STAFF REPORT: 7/12/2023 REGULAR MEETING

APPLICATION NUMBER: #23-8441

ADDRESS: 729 SEWARD

SCOPE: REPLACE WOOD WINDOWS WITH ALUMINUM-CLAD WINDOWS, PAINT PORCH (WORK COMPLETED WITHOUT APPROVAL)

Figure 1, by Applicant 2023: Window head detail, showing 3” recessed inset from exterior wall.

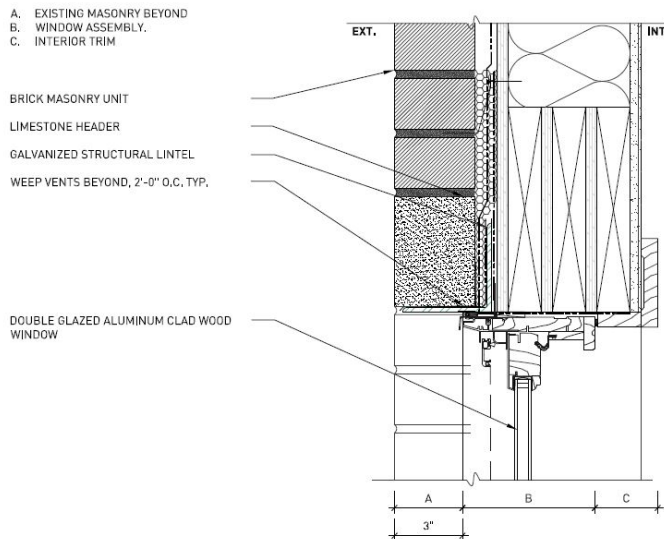
- While this application addresses the previously stated issue regarding the flat, wall-like feature that the current installation has created by recessing the unapproved windows deeper into the window openings, it is staff's opinion that the removal of the original wood windows alters the original *design and materiality* and introduces new windows that are incompatible and inappropriate for this historic property, and therefore does not meet the Secretary of the Interior's Standards for Rehabilitation. Some double-hung windows were replaced with single-hung windows, altering the original window's operation.

Staff finds that the replacement of the original wood windows does not meet the Secretary of Interior Standards for the following reasons:

- The windows that were removed without approval were a distinctive historic feature that characterized the property. The windows dated to the building's original construction and included 1/1 double-hung wood units.
- The application does not include documentation that the windows removed without approval were deteriorated beyond repair to an extent that merited their replacement.
- Some double-hung windows were replaced with single-hung windows.

Staff therefore recommends that the Commission issue a Denial for the proposed window replacement, as it does not meet the district's Elements of Design nor meet the Secretary of the Interior's Standards for Rehabilitation, specifically Standards:
